Carrigaline UDF and Public Realm

Stage 1 - Road Safety Audit

Cork County Council

February 2024

Figure 2-2 - Service Access and Adjacent Features

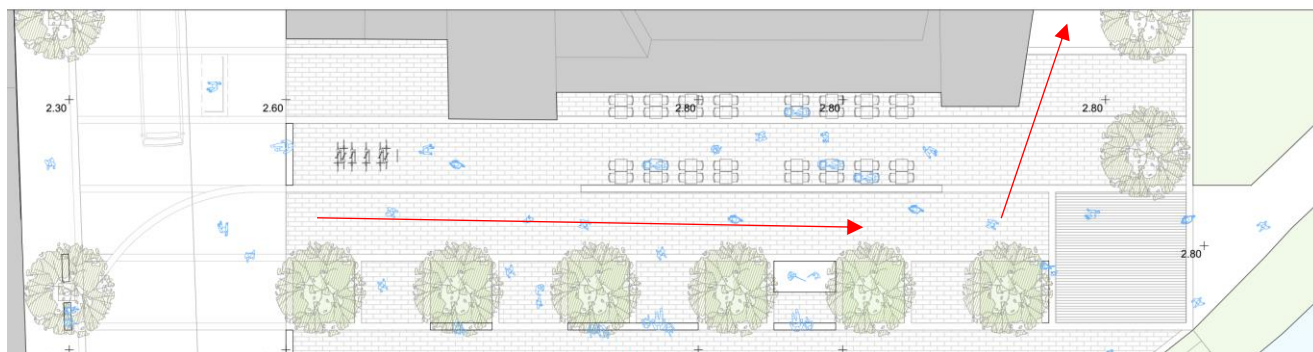
2.4. Problem: Potential Obstacles to the Service/Delivery Vehicle Access Route

The proposed layout includes some features such as large trees and low walls/benches adjacent to the service/delivery vehicle access route which may cause an obstacle for the large service/delivery vehicles that will likely be using the route. The proposed layout also indicates that the service/delivery vehicles will be forced to turn and travel in very close proximity to the south-eastern corner of the cluster of commercial buildings with exits/entrances along this eastern side of the building block. These potential obstacles may lead to collisions causing material damage or injury.

The separation to entrances/exits and the selection and siting of trees and other physical features should be considerate of the likely traffic using the service/delivery route.

Figure 2-4 - Proposed Details of the Stepped Embankment

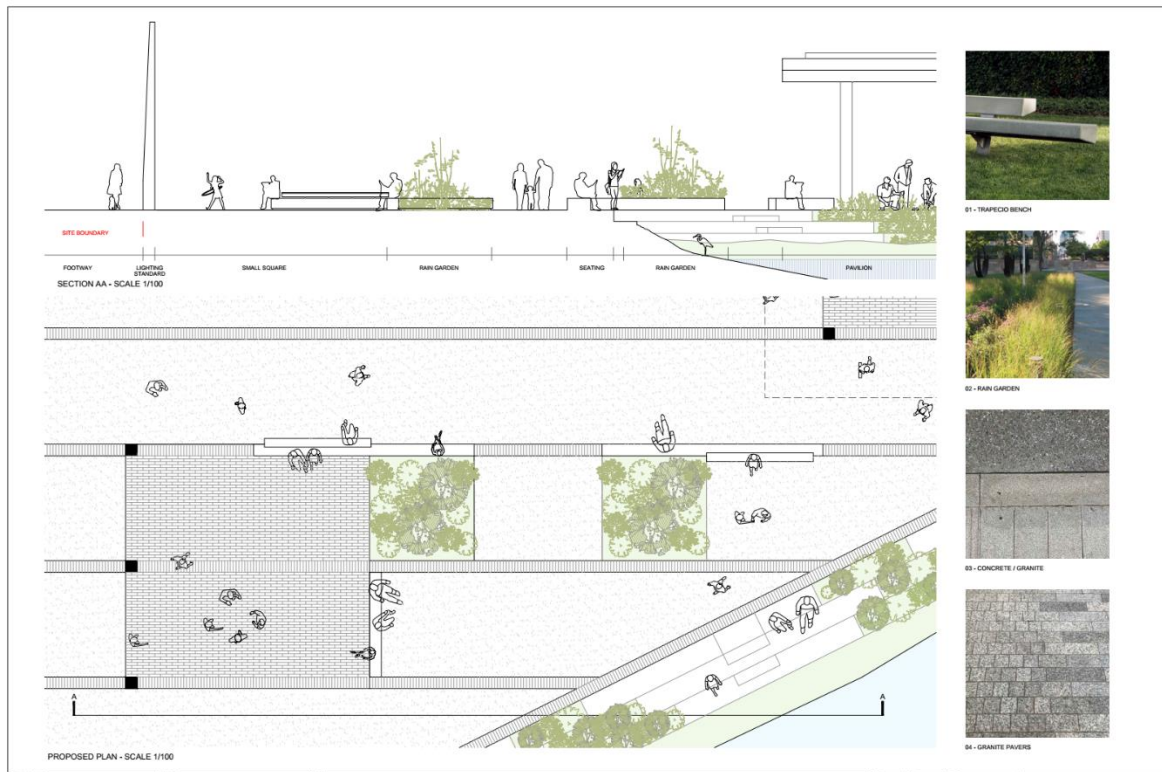
2.6. Problem: Potential Falls into the River

It is unclear from the drawings whether the stepped embankment is above the maximum tidal water level, if not the steps could become slippery from deposits of mud and algae resulting in slips trips and falls. In addition, it is unclear from the drawing whether the existing railing along the south side of the existing footpath from beyond the proposed embankment area is to be removed or replaced. If no railing is provided this could lead to pedestrians or cyclist falling into the river. The Owenabue River is a significant width and depth, which would increase the severity of an incident such as this.

Ensure that adequate protection measures are in place to prevent falls into the river along the entire length of the scheme.
